# **Asotin County Public Utility District** 1500 Scenic Way, Clarkston WA 99403

Project: 2024 Sewer Main Replacement Project - Design Package 2

## **ADDENDUM NO. 1**

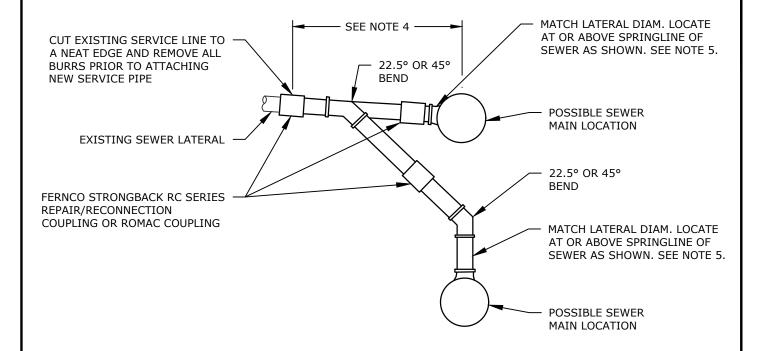
6. What is the distance intended to replace sewer laterals? Who warranties that distance?

Response: Per PUD standard detail 2-12, the sewer lateral shall be re-connected within 5 feet of the sewer main. Contractor shall warranty this portion of the sewer main within the 5-foot distance. Any additional length of lateral past 5' from the centerline shall be warranted if provided under the additional 4" PVC lateral bid item.

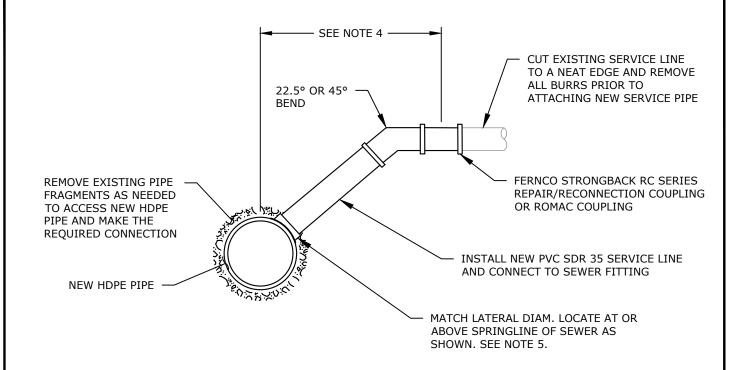
Asotin County PUD 2024 Sewer Main Replacement Drawings Sheet C-502, Detail 2-11 REPLACE with the attached revised drawing no. 2-11 dated November 2025.

Asotin County PUD 2024 Sewer Main Replacement Drawings Sheet C-502, Detail 2-12 REPLACE with the attached revised drawing no. 2-12 dated November 2025.

Revision Note: Romac CB's cannot be utilized for HDPE pipe per manufacturer. Inserta Tees or Electrofusion are only to be used for sewer laterals connecting to HDPE pipe.

- IF SEWER LATERAL IS DAMAGED OR HAS TO BE RELOCATED DURING CONSTRUCTION, RELOCATE/REPAIR SEWER PIPE AND RECONNECT USING A FERNCO RC SERIES STRONGBACK COUPLING OR ROMAC COUPLING.
- 2. INSPECTION OF WORK IS REQUIRED AND MUST BE APPROVED BY THE PUD.
- 3. SEWER LATERAL PIPE SHALL BE SDR-35 AND JOINTS SHALL BE GASKETED.
- 4. CONNECTION TO THE EXISTING LATERAL SHALL BE WITHIN 5 FEET MAX FROM THE CENTERLINE OF PIPE.
- 5. SEWER LATERAL CONNECTION TO BE WYE OR ROMAC CB FOR PVC MAINLINE, INSERTA TEE OR FUSION COUPLING FOR HDPE MAINLINE.

- 1. IF SEWER LATERAL IS DAMAGED OR HAS TO BE RELOCATED DURING CONSTRUCTION, RELOCATE/REPAIR SEWER PIPE AND RECONNECT USING A FERNCO RC SERIES STRONGBACK COUPLING OR ROMAC COUPLING.
- 2. INSPECTION OF WORK IS REQUIRED AND MUST BE APPROVED BY THE PUD PRIOR TO BACKFILL.
- 3. SEWER LATERAL PIPE SHALL BE SDR-35 WITH GASKETED JOINTS.
- 4. CONNECTION TO THE EXISTING LATERAL SHALL BE WITHIN 5 FEET MAX FROM THE CENTERLINE OF PIPE.
- 5. SEWER LATERAL CONNECTION TO BE WYE OR ROMAC CB FOR PVC MAINLINE, INSERTA TEE OR FUSION COUPLING FOR HDPE MAINLINE.

# **SERVICE CONNECTION DETAIL NO.: 7**

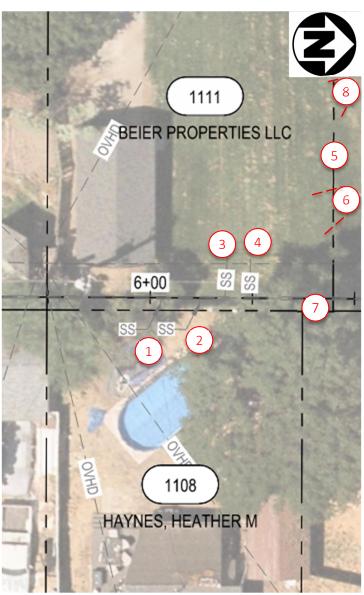
Service Connection Detail No. 7

REPLACE with the attached revised Service Connection Detail 7

- Added Keynote 8 to cover the removal and repair of a vinyl fence currently under construction. Fence is required to be removed for the pipe bursting receiving pit access.
- Added photo 1111-B to show the existing vinyl fence currently under construction.

KEY NOTE	DETAIL	PHOTO REFERENCE
5	ACCESS 1111 7 <sup>TH</sup> ST BETWEEN 1111 7 <sup>TH</sup> ST AND 1105 7 <sup>TH</sup> ST PROPERTIES	
6	REPLACE CHAIN-LINK FENCE WITH PRIVACY SLATS IN-KIND WHERE DISTURBED BY LATERAL RECONNECTIONS REPLACE DISTURBED GRASS WITH SOD REFERENCE PHOTO 1111-A LOCATION	1111-A
7	PIPE BURSTING PIT SURFACE RESTORATION IS INCLUDED IN THIS DETAIL 7. SEE CIVIL SHEET C-102.	
8	ACCESS TO PROPERTIES 1111 $7^{TH}$ ST AND 1103-1105 $7^{TH}$ ST WILL BE THROUGH VINAL FENCE. ASSUME FENCE WILL BE COMPLETED BEFORE THE START OF CONSTRUCTION.	1111-B
